Silicon Anomaly List

ADSP-BF531/BF532/BF533

ABOUT ADSP-BF531/BF532/BF533 SILICON ANOMALIES

43. 05000471 - Boot Failure When SDRAM Control Signals Toggle Coming Out Of Reset:**DESCRIPTION:**

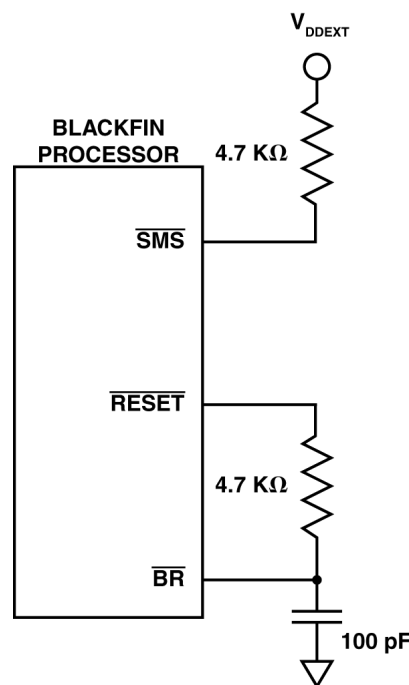
When $\overline{\text{RESET}}$ is de-asserted at the conclusion of the power-on reset sequence (not applicable to warm resets), there is a very small chance that the SDRAM control signals ($\overline{\text{SRAS}}$, $\overline{\text{SCAS}}$, $\overline{\text{SWE}}$, $\overline{\text{SMS}}$, $\overline{\text{SCKE}}$, and $\overline{\text{SA10}}$) may be driven low for a single CLKOUT cycle. This activity can cause certain SDRAM devices to enter engineering test modes that result in the SDRAM driving data onto the shared EBIU data lines that the Blackfin processor is going to read from when configured to boot or execute from parallel flash.

When booting from parallel flash (BMODE = b#01), this contention corrupts the boot stream and causes the processor to hang. At this point, power-cycling the processor is required to clear the condition.

When executing from parallel flash (BMODE = b#00), this contention corrupts the op-codes and causes the processor to execute incorrect or illegal instructions, which may result in improper application execution or unexpected exceptions.
